DESCRIPTION OF PROPOSED CHANGE
AND SAFETY AND ENVIRONMENTAL ANALYSES
PROPOSED CHANGE NO. 110 TO THE TECHNICAL SPECIFICATIONS
PROVISIONAL OPERATING LICENSE DPR-13

This is a request to revise Section 6.0, "Administrative Controls," of the Appendix A Technical Specifications and Section 5.0, "Administrative Controls," of the Appendix B Technical Specifications for San Onofre Unit 1.

FIGURE 6.2.3.1

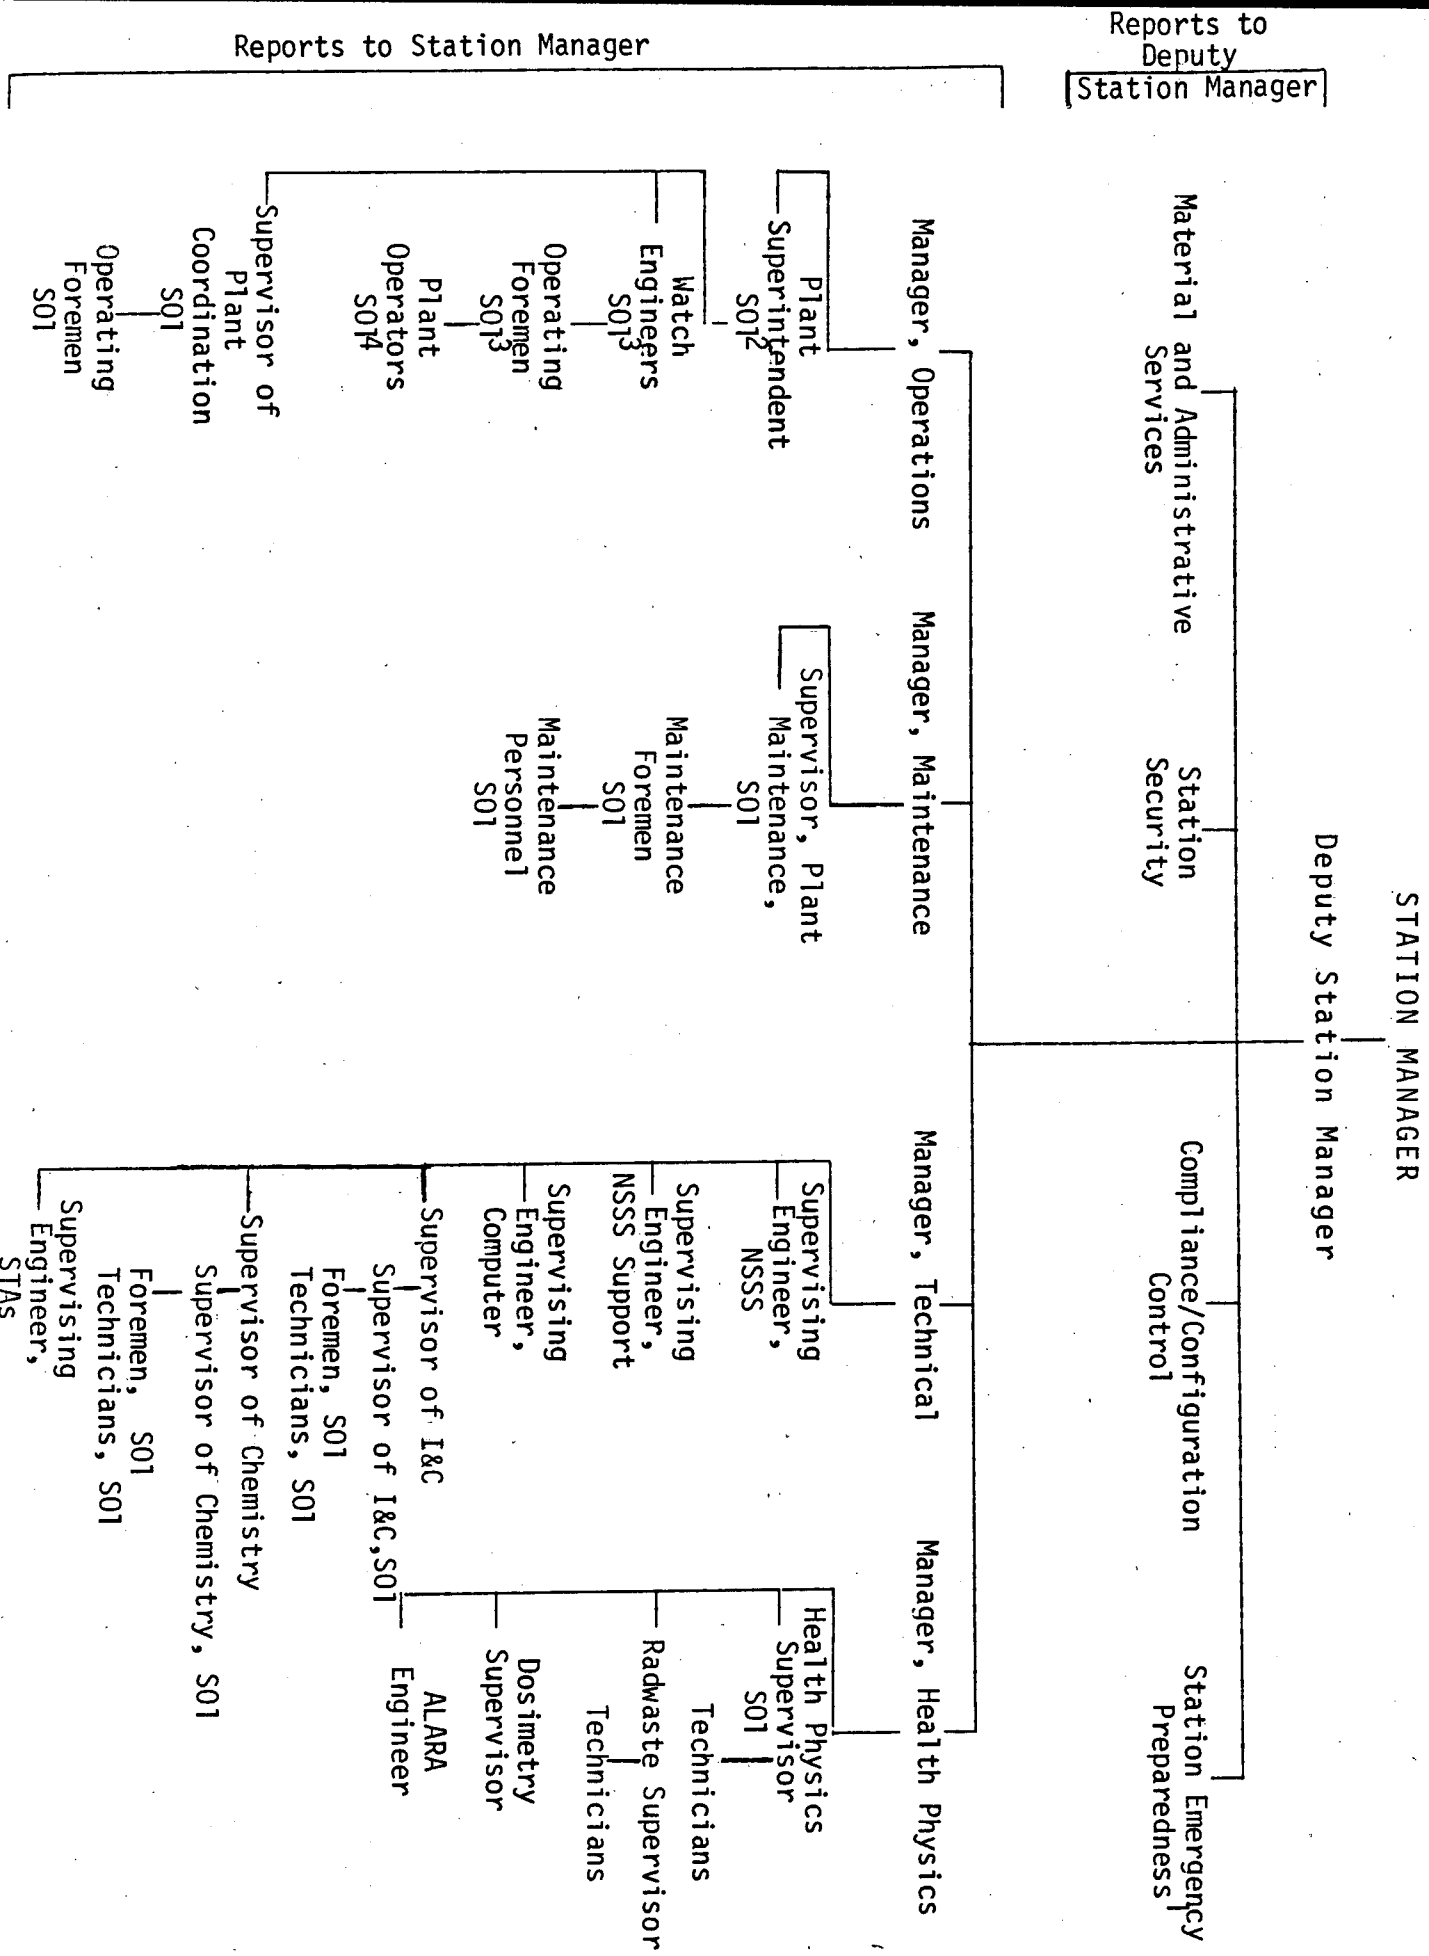
- (A.1) "6.1.1 The Station Manager shall be responsible for overall facility operation and shall delegate in writing the succession to this responsibility during his absence."
- (A.2) Enclosed Figure 6.2.2.2 would replace the existing Figure 6.2.2.2.
- (A.3) Enclosed Figure 6.2.3.1 would replace the existing Figure 6.2.3.1.
- (A.4) "6.3.1 Each member of the facility staff shall meet or exceed the minimum qualifications of ANSI N18.1-1971, "Selection and Training of Personnel for Nuclear Power Plants," for comparable positions. The Manager, Health Physics shall meet or exceed the minimum qualifications of Regulatory Guide 1.8, September 1975."
